ADDENDUM NUMBER THREE

**REPLACEMENT ROOFING SYSTEM FOR
BRAINERD YFD CENTER ROOF**

**FOR THE CITY OF CHATTANOOGA, TENNESSEE
Contract Number Y-18-004**

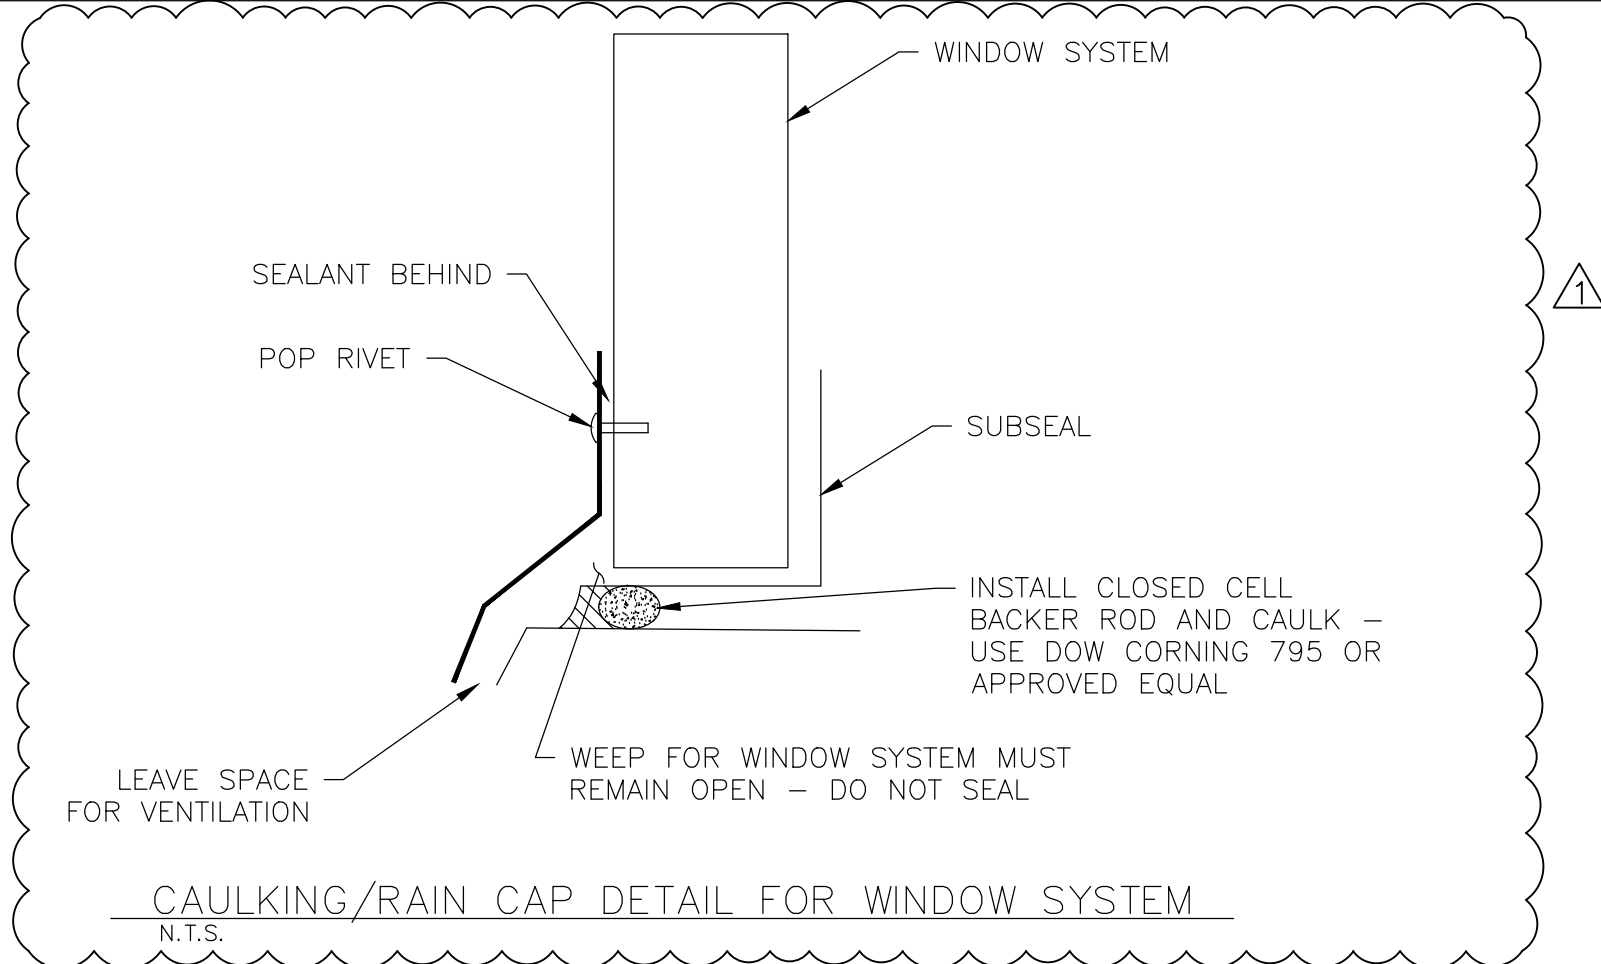
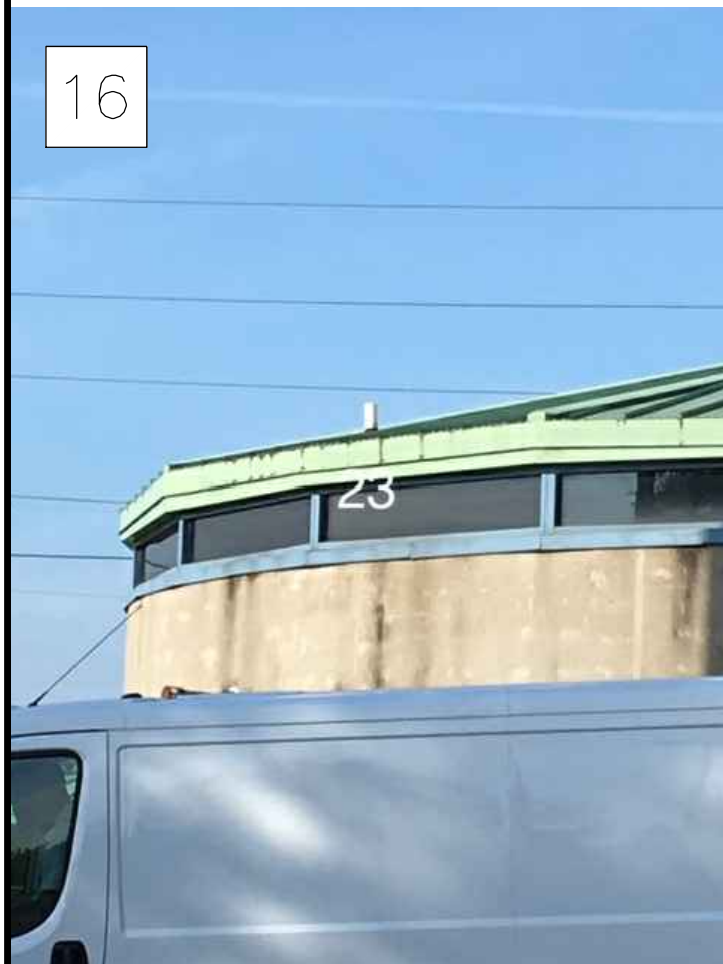
Addendum 1, Item 5 discussed a solution for the best way to handle water at the base of the window unit, where the flashing appears to slope backward toward the window. The solution presented was to fabricate a "rain cap", to be installed on the face of the window system, below the rubber seal, that would prevent water from reaching the existing flashing, but instead would guide it past the flashing, but would still allow the weep system of the window system to drain.

A detail has been added to sheet 6 of the plan set. Sheet 6 (attached) is replaced with the new Sheet 6-A, attached.

Please proceed with bidding with this "rain cap" as part of the bid. The Bid Schedule has been revised to include this information.
